SERVICE BULLETIN

12V Truck Control Pack Wire Harness Color Change (5 and 6 wire diagrams with BLACK Motor Ground Wire)

NEW 5-WIRE SCHEMATIC 12VDC

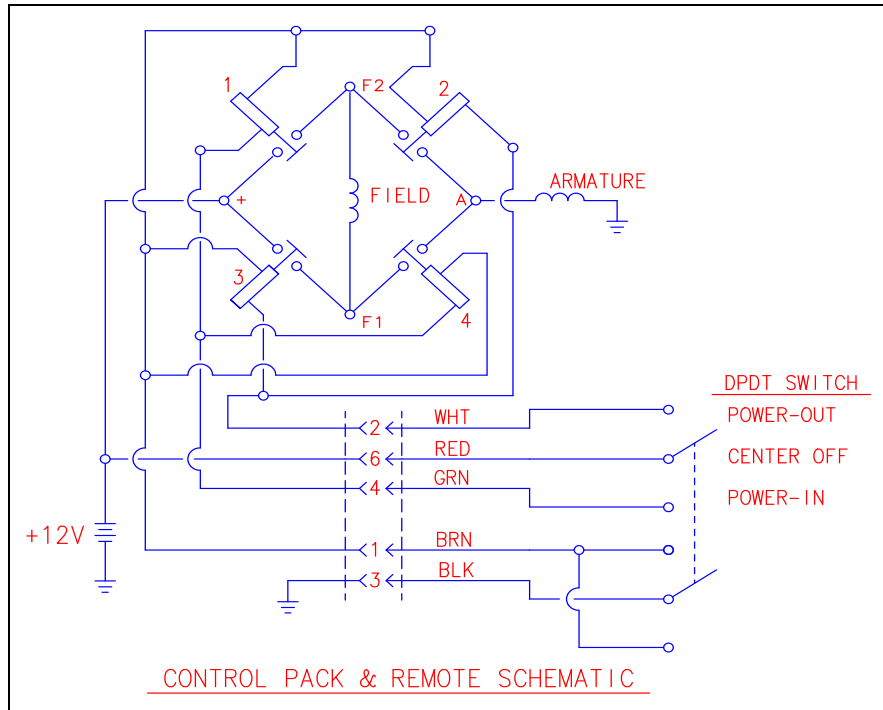
The color changes are as follows:

Motor ground wire from red to black

12Vdc wire from white to red

Power-out from black to white

The new 5-wire circuit diagrams are shown here:

NEW 5-WIRE REMOTE WIRING

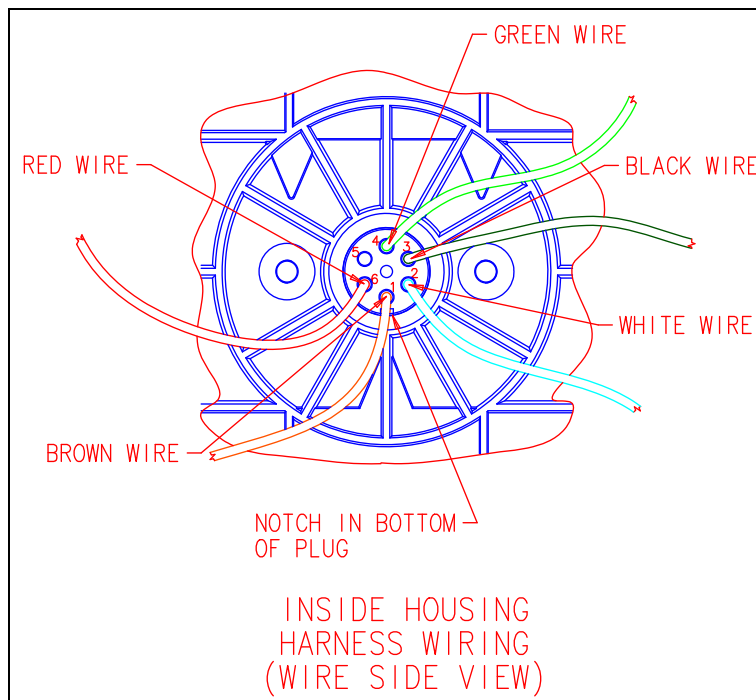
The following diagram is for routing the wires to the remote receptacle.

NEW 5-WIRE STANDARD CONTROL PACK WIRING

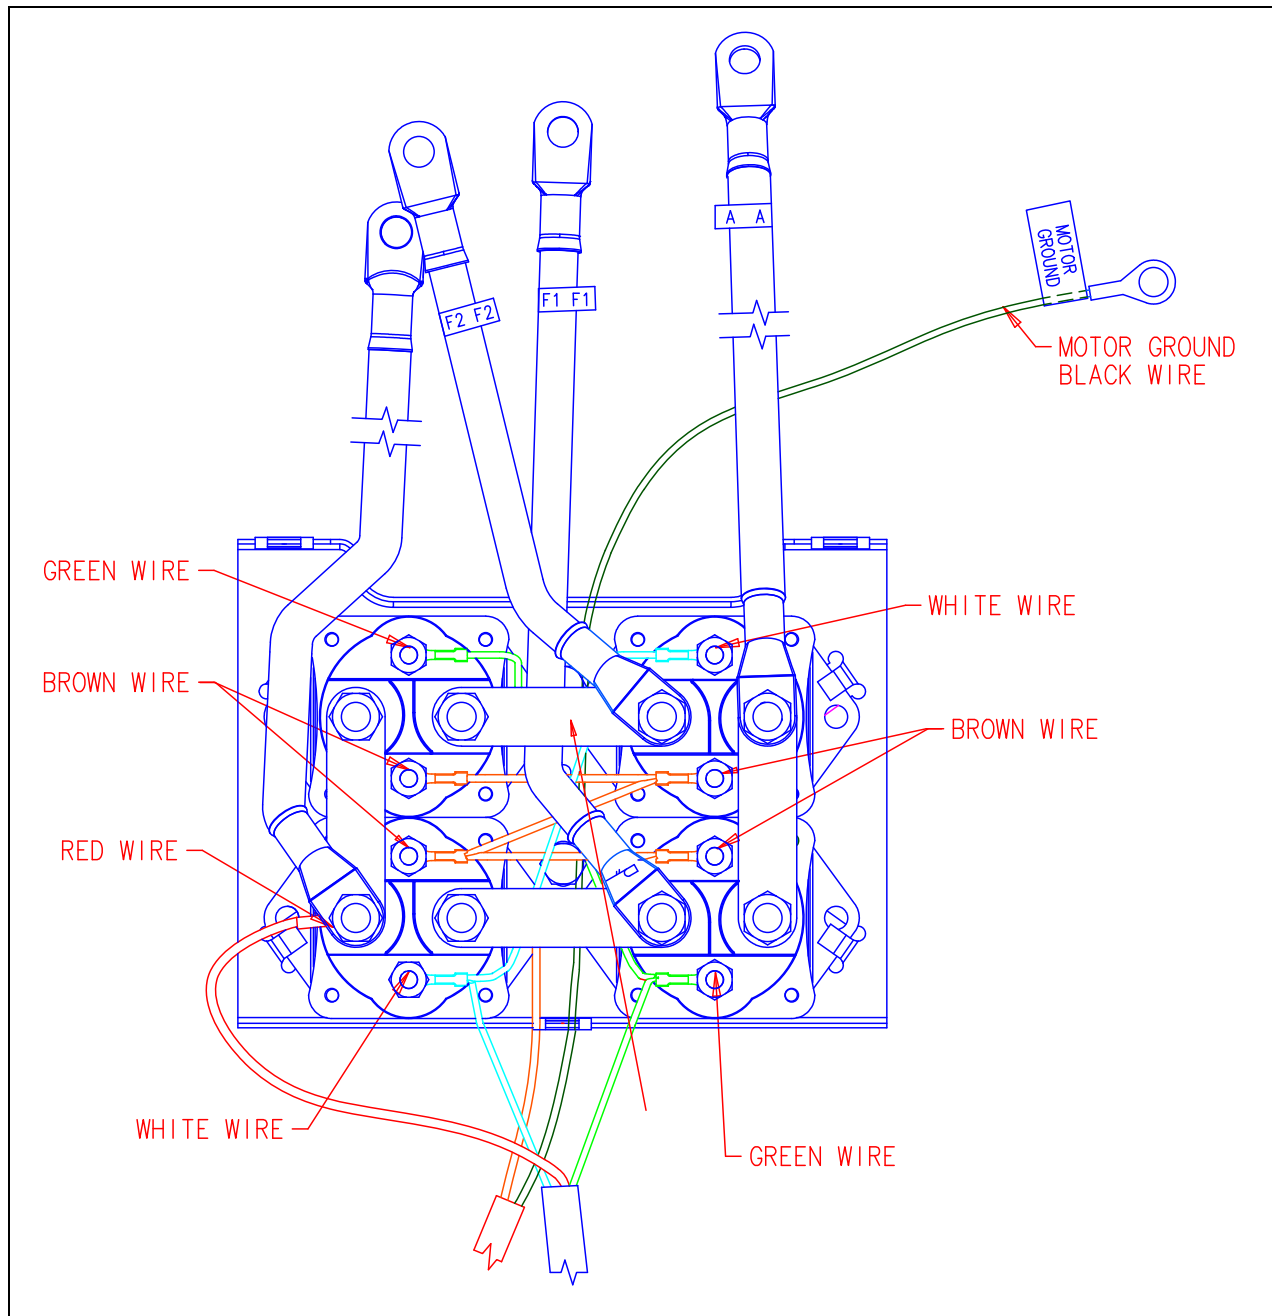
The following drawing is for routing the wires in the control pack to prevent heat damage from the bus bars in a 5-wire standard control pack configuration.

NEW 5-WIRE INLINE CONTROL PACK

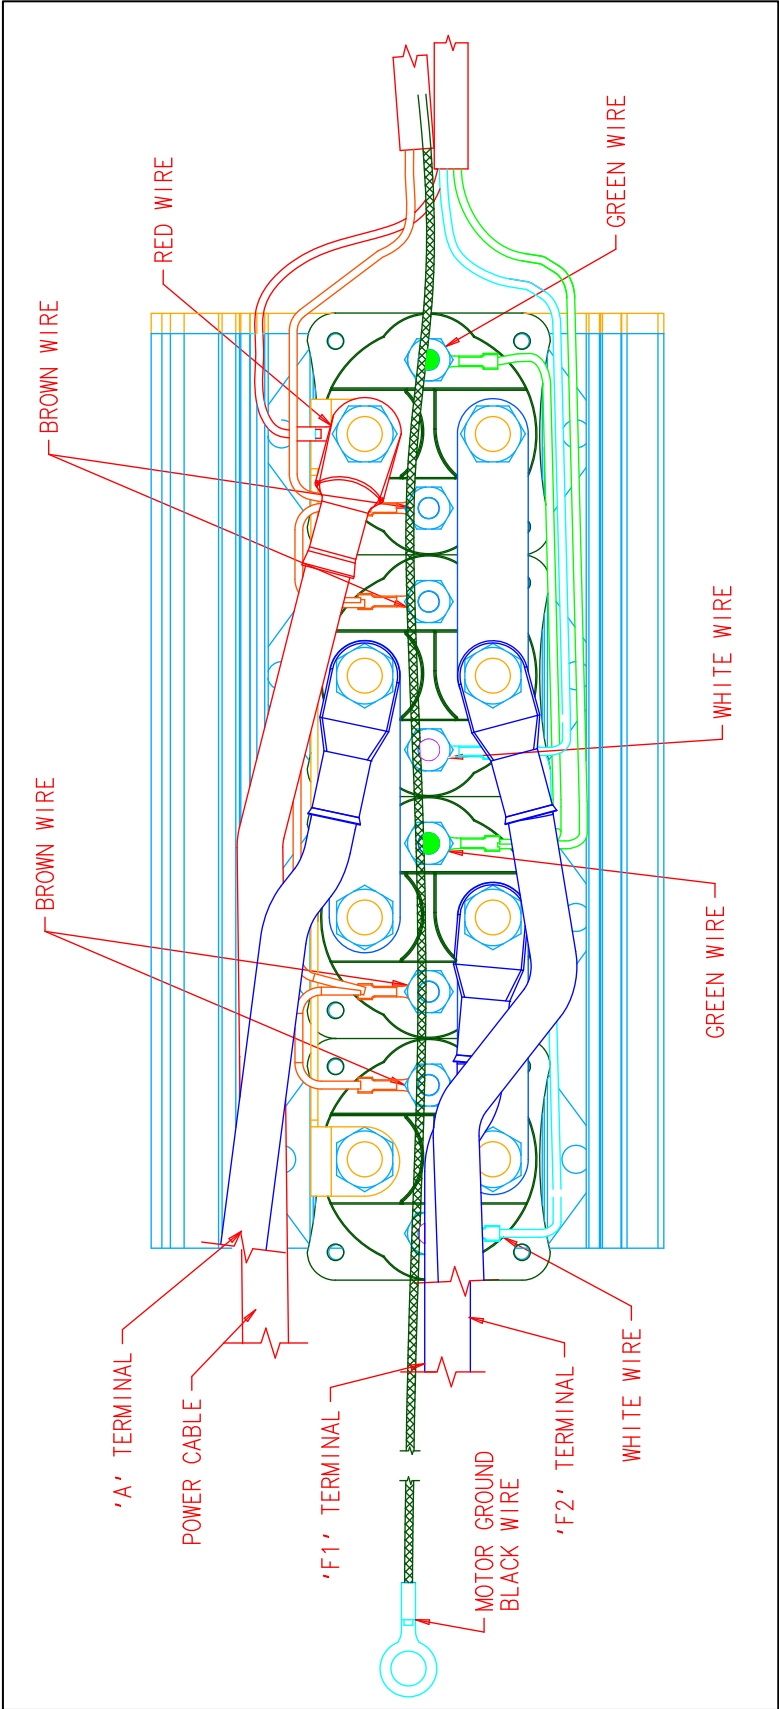
The following drawing is for routing the wires in the control pack to prevent heat damage from the bus bars in a 5-wire inline control pack configuration.

NEW 6-WIRE SCHEMATIC 12VDC

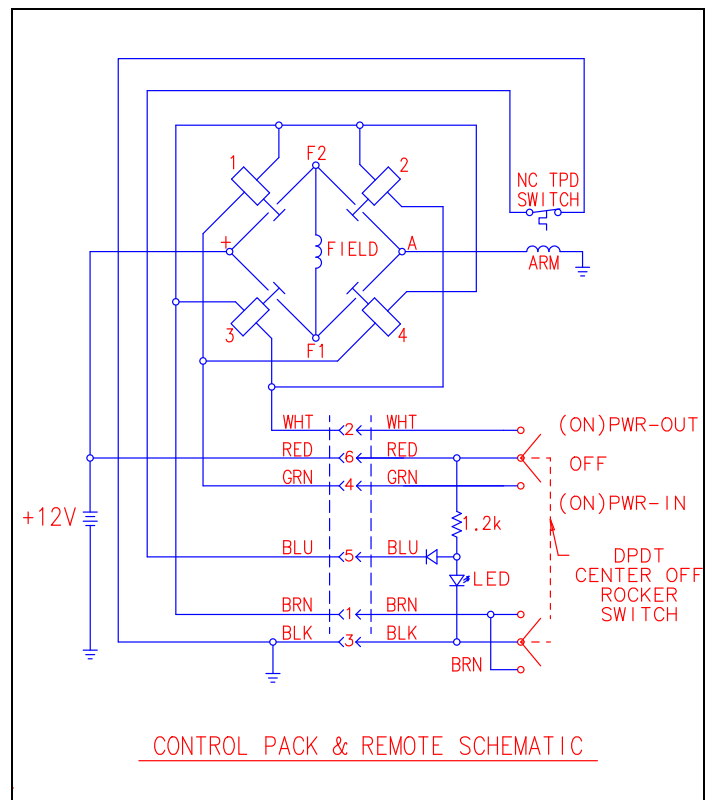
TPD wire will remain blue (for 6-wire control packs)

The new 6-wire circuit diagrams are shown below:

NEW 6-WIRE REMOTE WIRING

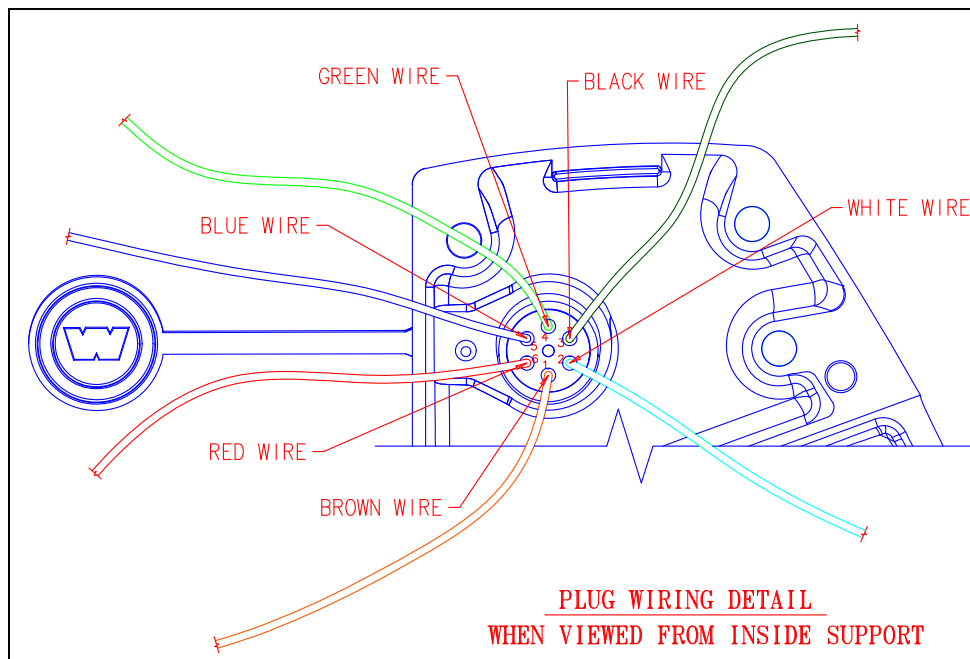
The following diagram is for routing the wires to the remote receptacle.
